Access Compliance Report

Public Rights-of-Way

(Curb Ramps)

Intersection ID: 4530	Main Street: BROOKSHIRE_BV	Cross Street: MT_HOLLY-HUNTERSVILLE_RD	Location: SW
ADA ID: 191394338E37	Ramp Type: BlendTrans1	Initial Pass/Fail: Fail	Overall Compliance: No
		Severity Score: 8.75

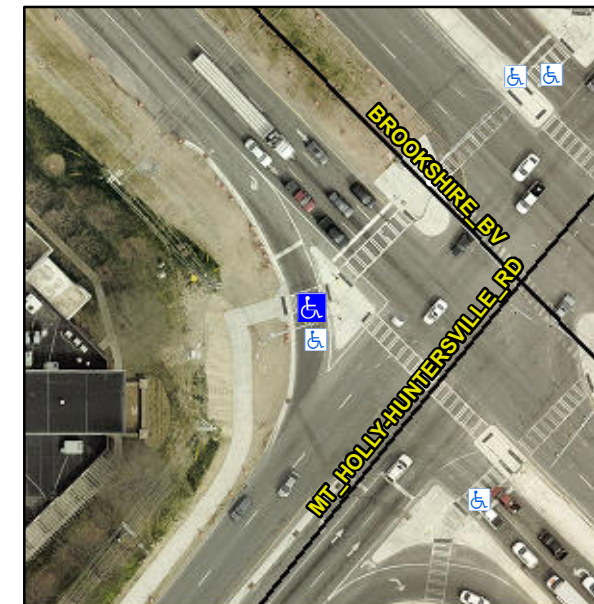
R304.5.1

Compliance	Description	Data	Compliance	Description	Data
N/A	Ramp Length (in)	66.0	Yes	BlendTrans Slope (%)	4.0
No	Ramp Width (in)	47.0	Yes	BlendTrans XSlope (%)	1.2
N/A	Flare Type LT	N/A	N/A	Flare Type RT	N/A
N/A	Flare Slope LT (%)	N/A	N/A	Flare Slope RT (%)	N/A
N/A	Flare Traversable LT?	N/A	N/A	Flare Traversable RT?	N/A
N/A	Landing Length (in)	N/A	N/A	DWS Provided?	N/A
N/A	Landing Width (in)	N/A	N/A	DWS Contrast?	N/A
N/A	Landing Slope (%)	N/A	N/A	DWS Length (in)	N/A
N/A	Landing X Slope (%)	N/A	N/A	DWS Full Width?	N/A
N/A	Landing Curb? (Y/N)	N/A	N/A	DWS Offset (in)	N/A
N/A	Shared Landing?	N/A			
N/A	Gutter Ponding?	N/A	N/A	Gutter Slope (%)	N/A
N/A	Gutter Lip Ht (in)	N/A	N/A	Gutter X Slope (%)	N/A
N/A	Painted X Walk1?	Yes	N/A	Painted X Walk2?	N/A
	X Walk 1 Direction	To NE		X Walk 2 Direction	N/A
	X Walk 1 Width (in)	111.0		X Walk 2 Width (in)	N/A
	X Walk 1 Slope (%)	1.4		X Walk 2 Slope (%)	N/A
	X Walk 1 X Slope (%)	0.2		X Walk 2 X Slope (%)	N/A

Remove & Replace Curb Ramp With Two New Directional Ramps or Equivalent.
